**Public Works Subcommittee Meeting on 10 June 2017**  
**Issues requiring follow-up actions by the Administration**

**PWP Item No. 786CL – Tung Chung New Town Extension**  
**Reclamation and Advance Works**

東涌新市鎮擴展 - 填海及前期工程 - 生態海岸線平面圖  
 TUNG CHUNG NEW TOWN EXTENSION - RECLAMATION AND ADVANCE WORKS  
 - ECO-SHORELINE LAYOUT PLAN

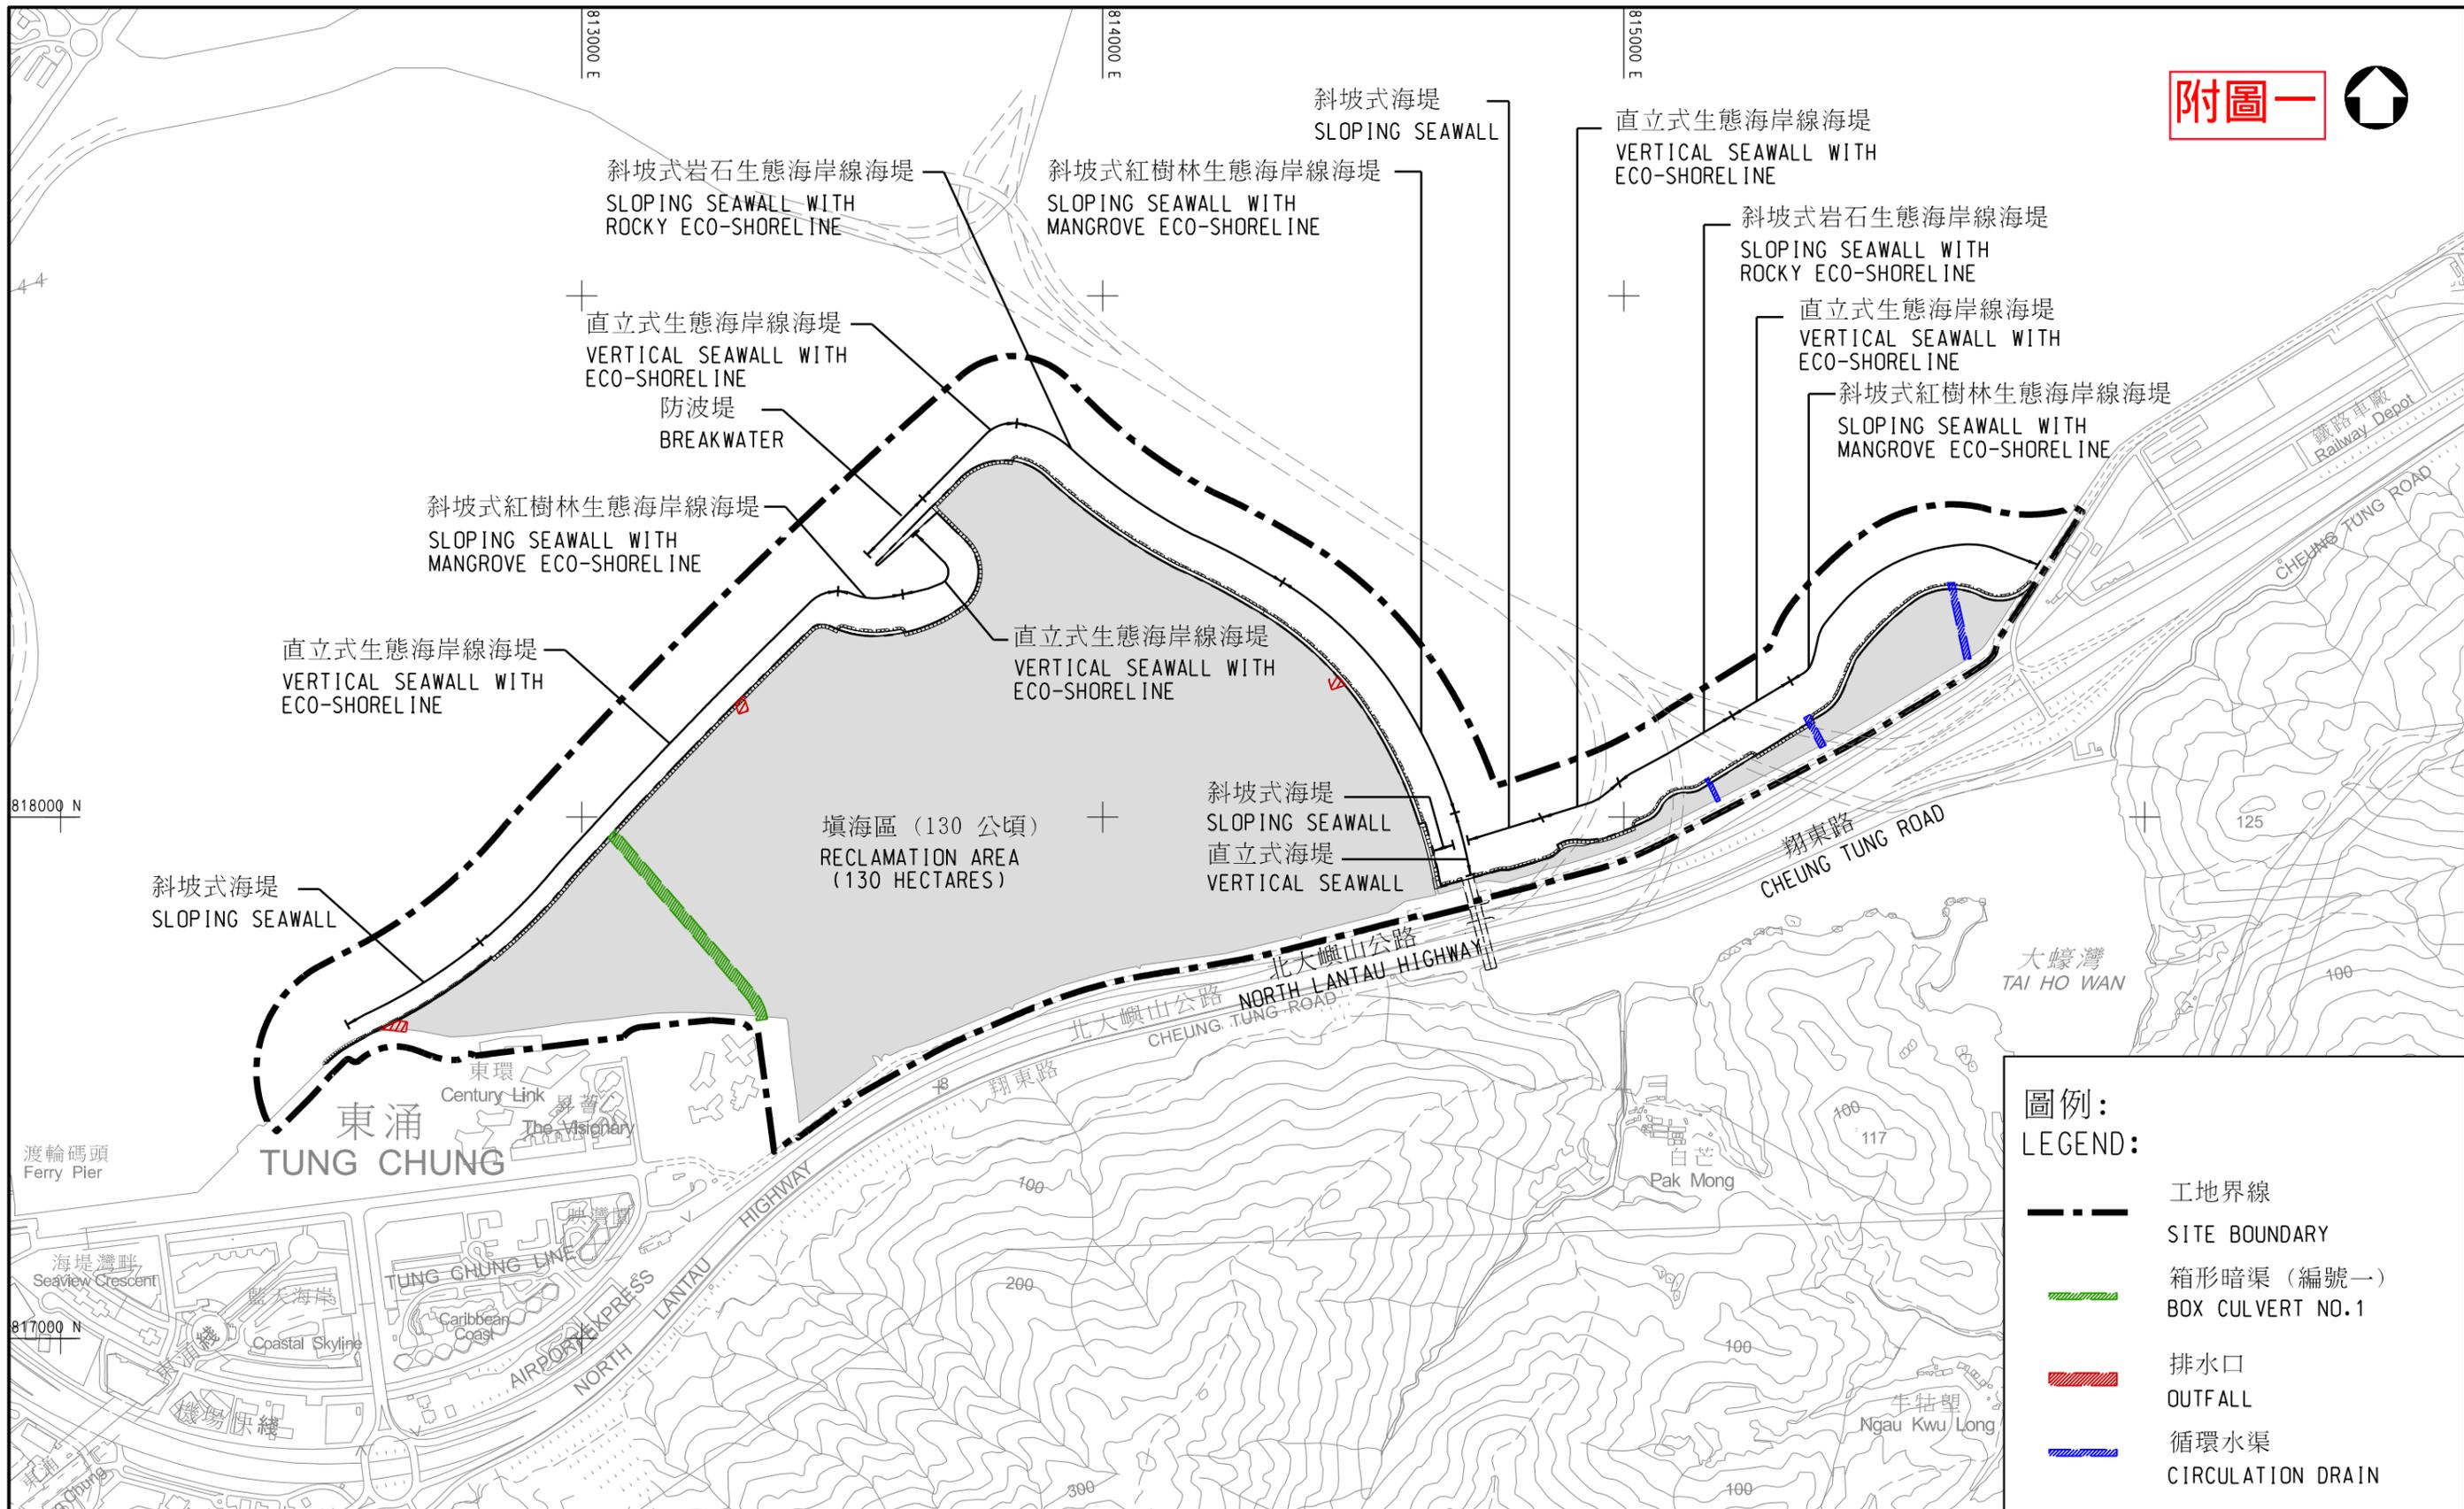
*“At the request of Hon Tanya CHAN, the Administration should provide supplementary information such as illustration diagram, location plan and design plan of the eco-shoreline to be provided along the proposed seawall at Tung Chung East (TCE).”*

2. PWP Item No. 786CL – Tung Chung New Town Extension – Reclamation and Advance Works is the first public works project adopting eco-shorelines, with the primary objective of mimicking the physical properties of natural inter-tidal zones as far as practicable, in a bid to provide a more suitable habitat, namely a tidal eco-system, for colonisation of marine species. On the location of the eco-shoreline (see **Diagram 1**), we need to take into account various environmental factors and constraints in the vicinity of the shoreline, such as salinity of the water body, susceptibility of the shoreline to sea waves and abundance of sunlight. Mangrove eco-shorelines (see **Diagram 2**) would be provided at inter-tidal zones along the seashore less susceptible to sea waves. In addition, seawall blocks would be laid along the seaward side to reduce the wave action which may affect the mangroves. On another front, mangrove eco-shorelines would be provided near the drainage box culvert outfall and outlet of Tai Ho Bay. As mentioned in paragraph 8 of LegCo Paper No. PWSC192/16-17(01), the lower salinity of the water body there and natural nutrients from catchment areas may promote the growth of mangroves.
